Project	IEEE 802.16 Broadband Wireless Access Working Group < <a href="http://ieee802.org/16">http://ieee802.org/16</a> >	
Title	Subscriber Mode Management	
Date Submitted	2005-07-20	
Source(s)	Yun Won Chung, PhD Jee Hyeon Na, Sang Ho Lee, PhD ETRI, 161, Gajeong-dong, Yuseong-gu, Daejeon, 305-700, Korea	<a href="mailto:yun.chung@etri.re.kr">yun.chung@etri.re.kr</a> <a href="mailto:jhna@etri.re.kr">jhna@etri.re.kr</a> <a href="mailto:leesh@etri.re.kr">leesh@etri.re.kr</a> Voice: +82-42-860-5244 Fax: +82-42-861-1966
Re:	Call for Comment on P802.16g Baseline Document	
Abstract	This contribution proposes subscriber mode management.	
Purpose	The document should be considered during the resolution of comments on the baseline document.	
Notice	This document has been prepared to assist IEEE 802.16. It is offered as a basis for discussion and is not binding on the contributing individual(s) or organization(s). The material in this document is subject to change in form and content after further study. The contributor(s) reserve(s) the right to add, amend or withdraw material contained herein.

# Subscriber Mode Management

Fig. 3 - Subscriber Mode transition diagram at MS and BS

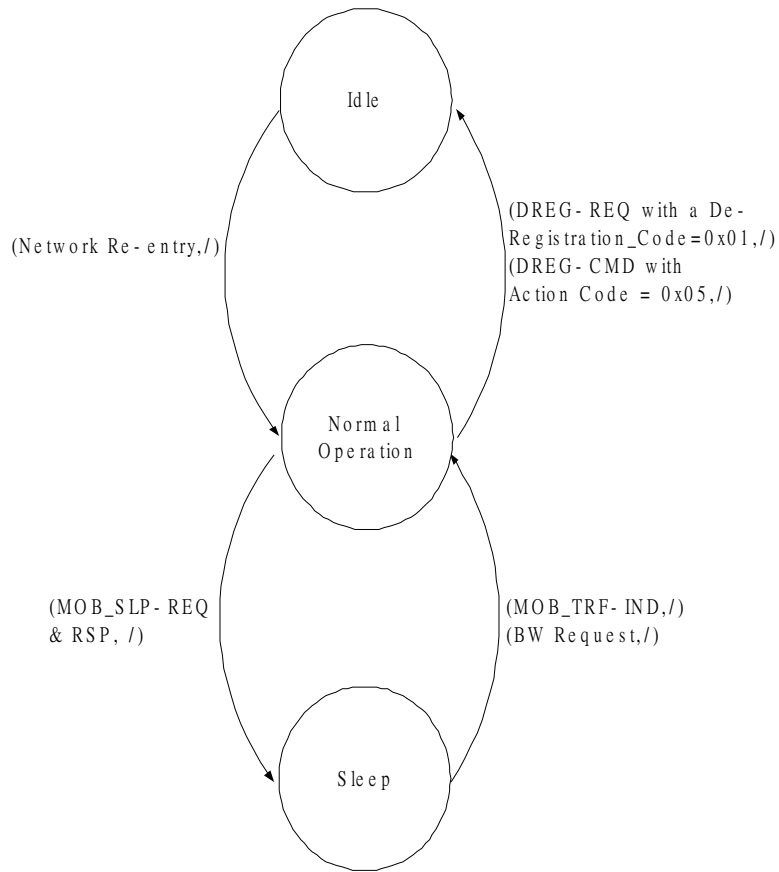
Figure 3 shows Subscriber Mode transition diagram at both an MS and a BS. Subscriber Mode at both an MS and a BS changes from Normal Operation to Idle Mode when the MS issues an MS De-registration Request (DREG-REQ) message with `De-Registration_Request_Code=0x01` or the BS issues an De-register Command (DREG-CMD) message with `Action Code = 0x05`. Then, the MS stays at Idle Mode and updates its location when the paging group changes. The Subscriber Mode returns back to Normal Operation from Idle Mode after completing Network re-entry. Transition from Normal Operation to Sleep Mode is performed after an MS successfully exchanges Sleep Request (MOB\_SLP-REQ) and Sleep Response (MOB\_SLP-RSP) messages with a BS. If there is any DL traffic toward an MS from a BS, MOB\_TRF-IND is broadcast to the MS from the BS and Subscriber Mode of the MS and the BS changes from Sleep Mode to Normal Operation. If there is any UL traffic from an MS, Bandwidth Request (BW Request) is sent to the serving BS from the MS and Subscriber Mode of the MS and the BS changes from Sleep Mode to Normal Operation, too.

Fig. 4 - Subscriber Mode transition diagram at NCMS

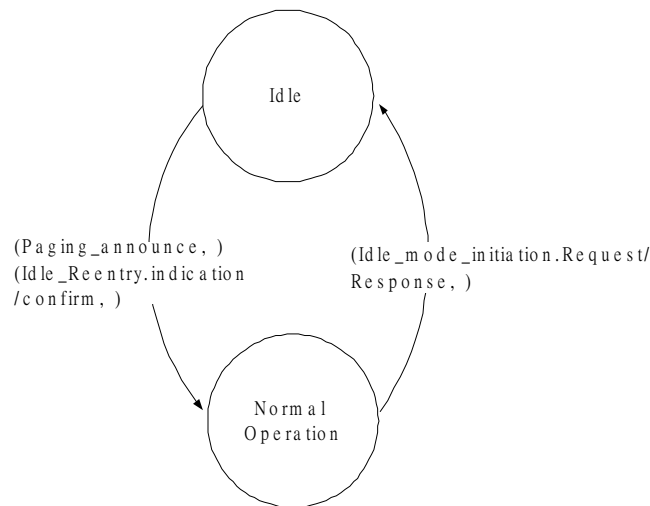
Figure 4 shows Subscriber Mode transition diagram at an NCMS with service primitives related with the Subscriber Mode transition. Subscriber Mode transition from Normal Operation to Idle Mode is performed by exchanging `Idle_mode_initiation.request` and `Idle_mode_initiation.response` between a BS and an NCMS after successful DREG-REQ message with `De-Registration_Request_Code=0x01` or DREG-CMD message with `Action Code = 0x05` between an MS and a BS, where `Idle_mode_initiation.request` and `Idle_mode_initiation.response` are defined in 14.5.11.1 and 14.5.11.2, respectively. Subscriber Mode transition from Idle Mode to Normal Operation is initiated after exchanging `Paging_announce`, `Idle_ReEntry.indication`, and `Idle_ReEntry.confirmation` between a BS and an NCMS, where `Paging_announce`, `Idle_ReEntry.indication`, and `Idle_ReEntry.confirmation` are defined in 14.5.11.3, 14.5.11.4, and 14.5.11.5, respectively.
